**DDRB-2014-005, 1024 Kings Avenue Development
Request for Final Approval and Deviations**

**DDRB APPLICATION 2014-005
1024 KING STREET**

Project Name: 1024 King Street, (formerly Southside Blue Print)
Exterior Improvements to existing structure

Request: Final Approval and Deviations

1 SITE AND LANDSCAPE PLAN

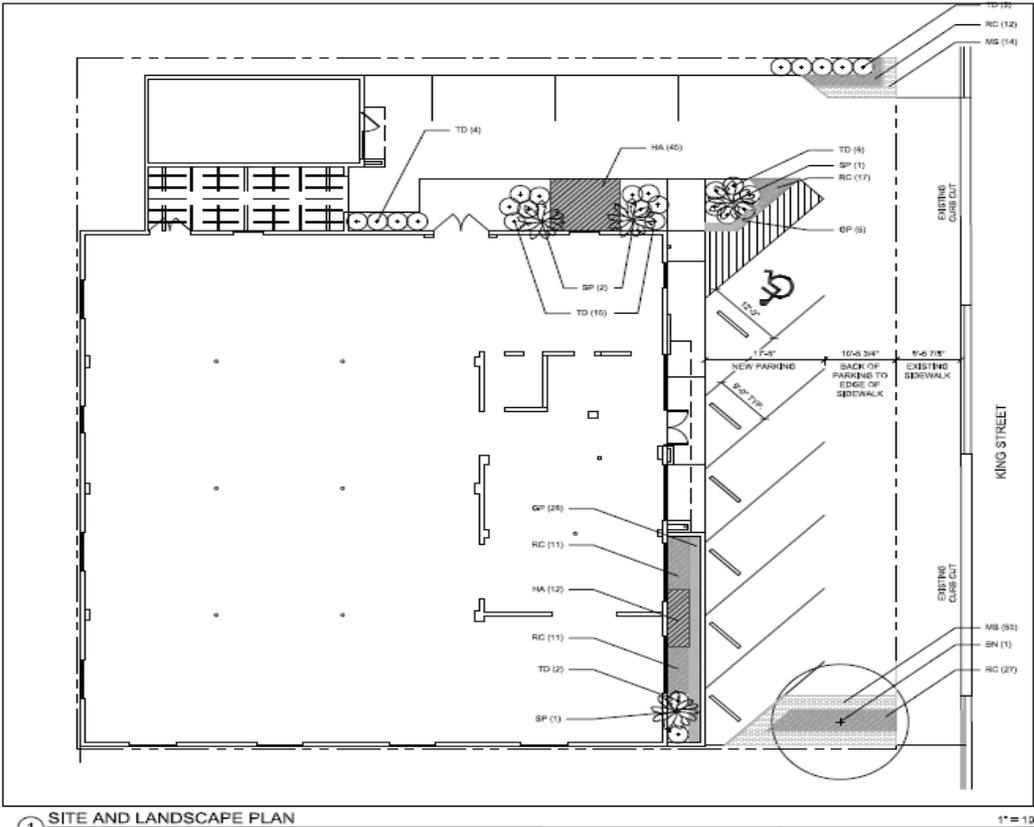
Staff notes the development shows 8 vehicle parking spaces and 1 handicap space for a total of 9 parking spaces. Per Code the project requires 24 parking spaces, **less 50%**, for a total of 12 parking spaces for the approximate 8,500 square feet of office space. It is noted that the proximity to the King Street Station ASE allows for a further **reduction of 25%**, for a total of 9 parking spaces. As such, the final drawings show compliance with this design guideline.

Staff notes that the project proposes to use the existing parking as the required parking for the proposed developed. Presently the parking is accessed by two drives from King Street. The area required to be screened per the development guideline would be the short distance between the two drives, approximately 10 feet. It is noted that providing landscape in this area would reduce the required internal parking and vehicle circulation creating unsafe views for traffic circulation to and from the site, as well as potential unsafe pedestrian views with regards to vehicle circulation. As such the development is **not** showing compliance with this design guideline. However, staff notes that the applicant does show additional landscape along the north and south property lines so as to mitigate this design requirement and support a deviation for an alternative design. Staff supports this alternative design and thus supports the deviation from this design requirement. **Note: The project will need to receive a deviation prior to final review and approval by the DDRB.**

Staff notes that the conceptual plan does **not** show compliance with this development guideline but would also note this design guideline is not evident in the general area or immediate block. Additionally there is limited space to make the required improvements on this site as well as others locations in the area, supporting a relief from this guideline. The guideline requires paving and landscape improvements in the King Street right-of-way between the drive access locations. As noted, there is minimal area to make the streetscape improvements to the development; however, there are opportunities to mitigate non-compliance with landscape improvements, including landscape plantings at the north and south property lines of the proposed project. Staff notes that the applicant does show additional landscape along the north and south property lines so as to mitigate this design requirement and support a deviation for an alternative design. Staff supports this alternative design and thus supports the deviation from this design requirement. **Note: The project will need to receive a deviation prior to final review and approval by the DDRB.**

1. A deviation from *Sec. 656.361.17.-Surface Parking, Trash, Storage, and Loading Area Screening and Landscaping Requirements* with the applicant providing landscaping adjacent to the eastern and northern façade of the building facing King Street and the as shown on the presented Site Plan/Landscape Plan; and
2. A deviation from *Sec. 656.361.20.-Streetscape Design Standards* with the applicant providing landscaping in the area along the south and north property lines, as an alternative to the required streetscape design for the King Street frontage; and
3. Final Approval of DDRB application 2014-005.
